South Texas Project Electric Generating Station P.O. Box 289 Wadsworth, Texas 77483

March 29, 2010  
U7-C-STP-NRC-100071

South Texas Project  
Units 3 and 4  
Docket Nos. 52-012 and 52-013  
Response to Request for Additional Information

**RAI 07.01-15****QUESTION:**

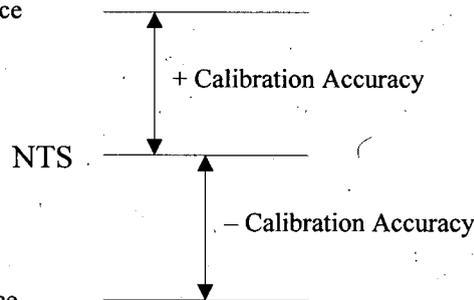
1. According to Figure 3-1 in WCAP-17119-P, the "as left" tolerance is same as the "as found" tolerance for the rack. Whereas Section 2.2, "Sensor Allowances" states that sensor calibration accuracy (SCA) is the difference between the "as left" value and the desired value, and Sensor drift (SD) is the difference between "as found" value and the "as left" value. Also as stated in Section 2.3, "Rack Allowances," rack calibration accuracy (RCA) is the difference between the "as left value and the desired value, and Rack drift (RD) is the difference between the "as found" and "as left" values. The applicant is asked to resolve the above stated discrepancies and clarify whether the "as left" value is same as the "as found" value, and also provide a description for the desired value.

1. To clarify the terms As Found and As Left, the following breakdown is provided to show the method for determining As Found and As Left for racks and sensors/transmitters.

The As Left condition is stated in Section 3.2 of WCAP-17119-P as the condition in which the rack is left following calibration or setpoint verification. Rack Calibration Accuracy (RCA) is the difference between the As Left value and the desired value, or Nominal Trip Setpoint (NTS). This is consistent with the statement in Section 2.3 of the WCAP. The “as left” limit is the As Left Tolerance and is defined in the plant calibration procedures. The As Left Tolerance is equal to the RCA term defined in the uncertainty calculations.

The As Found condition, stated in Section 3.2 of the WCAP, is the condition in which the rack is found after a period of operation. The difference between the As Left condition and the As Found condition is the difference between the trip setting at calibration at the beginning of a surveillance interval, and that determined through surveillance testing performed after a period of operation. This difference is also known as the Rack Drift (RD). The “as found” limit is the As Found Tolerance and is defined in plant surveillance procedures. In the case of digital racks, significant drift is not experienced or expected. The rack drift shown in the uncertainty calculations of WCAP-17119-P is quite small and has minimal effect on the uncertainty calculation, as compared to the RCA term. Therefore, as the RD term is considered insignificant, the As Found condition is expected to be well within the magnitude of  $\pm$ RCA about the NTS; and therefore, the As Found Tolerance is stated to be equal to the As Left Tolerance. Because As Found Tolerance is equal to As Left Tolerance, As Found Tolerance is equal to the RCA term defined in the uncertainty calculations.

Thus Figure 3-1 of the WCAP showing As Left Tolerance equal to As Found Tolerance is consistent with the statements in Section 3.3 and Section 2.3.

To clarify the differences between the As Found Tolerances in racks using the RCA term, the following clarification has been made to WCAP-17119-P Section 2.3 and also to the definitions of As Found Tolerance and Nominal Trip Setpoint in Section 3.2 of the WCAP.

The following statement has been added to the As Found Tolerance definition (underlined text):

“The “as-found” tolerance equals the instrument process rack calibration accuracy defined in the uncertainty calculation. This is based on the design premise that digital racks do not experience significant drift.”

The following statement has been added to the end of the Nominal Trip Setpoint definition:

“Evaluations of as left and as found data for analog and digital process racks suggest rack drift (RD) is significantly smaller than the procedure allowed as left tolerance. Thus, the expectation that the rack module is found within the as left tolerance, and the definition of AFT =ALT, as noted below.”
